ORIGINATION FORM

Proposed Revisions to a Standard Plans Index
(Please provide all information — Incomplete forms will be returned)

Index Number: 440-002
Sheet Number (s): 1 of 3
Index Title: Underdrain Inspection Box

===== UNDERDRAIN INSPECTION BOX ASSEMBLY =====

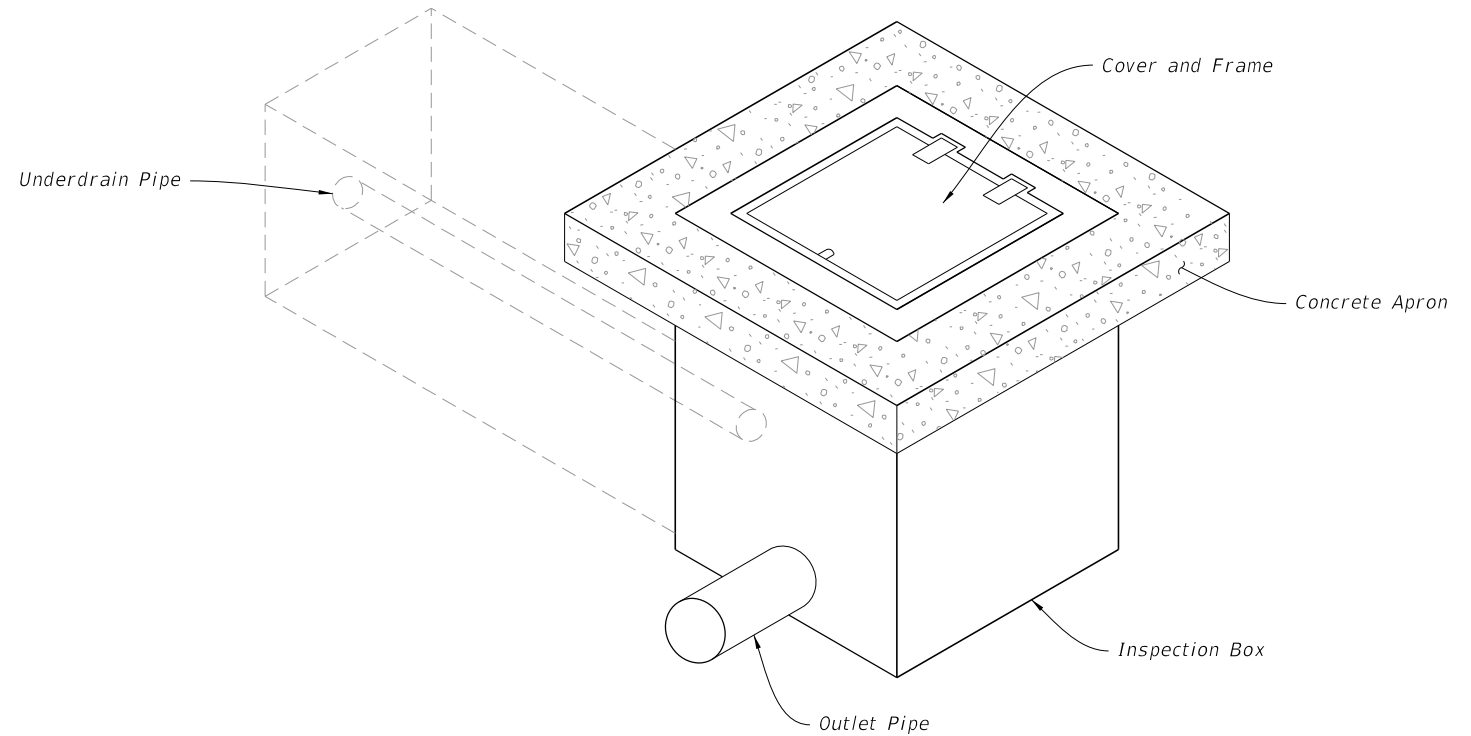
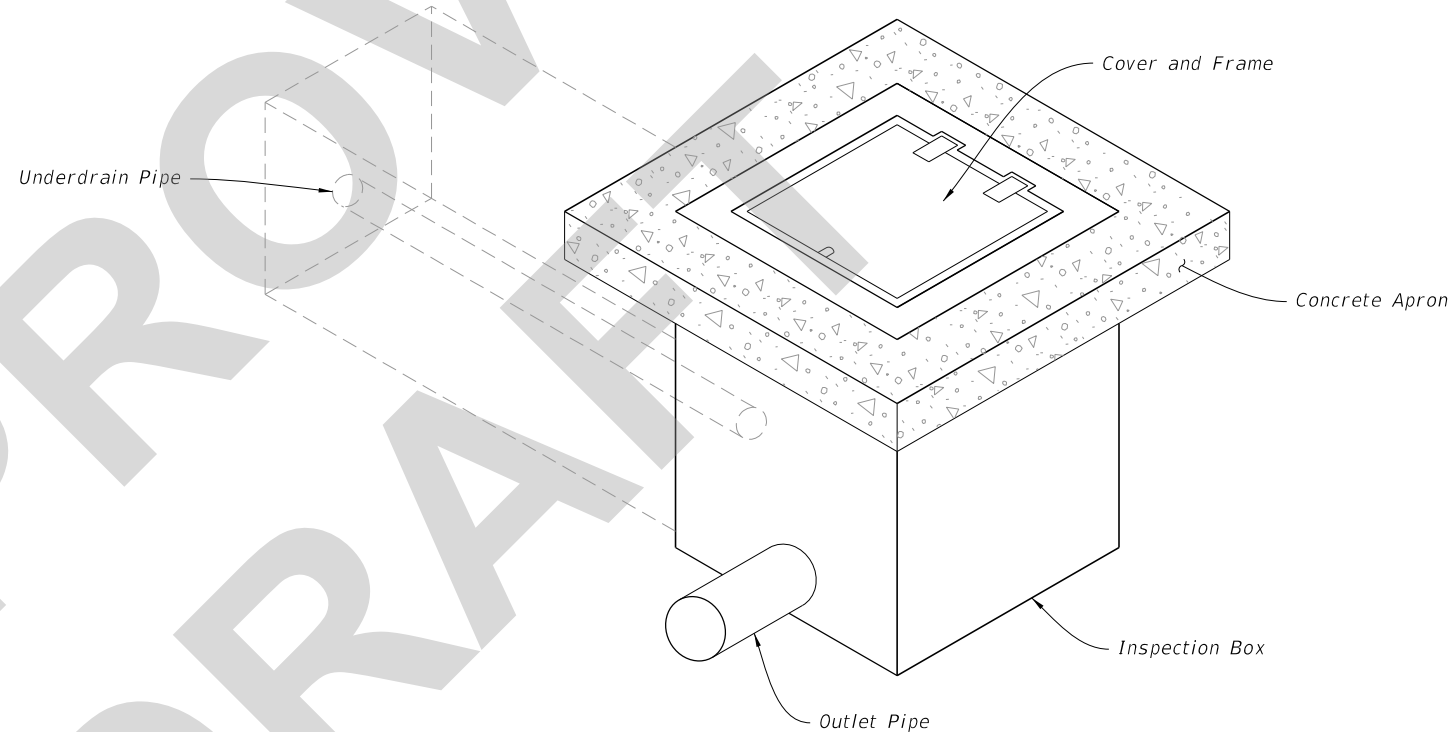
Sheet 1: Changed GENERAL NOTE 2 from "Class I" to "Class II".

CHANGED TO: Class II

1. Install light duty cast iron cover and frame in accordance with Specifications 962.
2. Use ~~Class I~~ concrete. Use No. 3 bars (Grade 60) on 8" centers both ways, sides and bottom.
3. Furnish covers with pick holes. Do not use fitted lifts or handles.
4. Manhole Type P Alternate A, Index 425-010, Type I Frame and Cover, Index 425-001, may be used in lieu of the box detailed in this Index.

1. Install light duty cast iron cover and frame in accordance with Specification 962.
2. Use Class II concrete. Use No. 3 bars (Grade 60) on 8" centers both ways, sides and bottom.
3. Furnish covers with pick holes. Do not use fitted lifts or handles.
4. Manhole Type P Alternate A, Index 425-010, Type I Frame and Cover, Index 425-001, may be used in lieu of the box detailed in this Index.
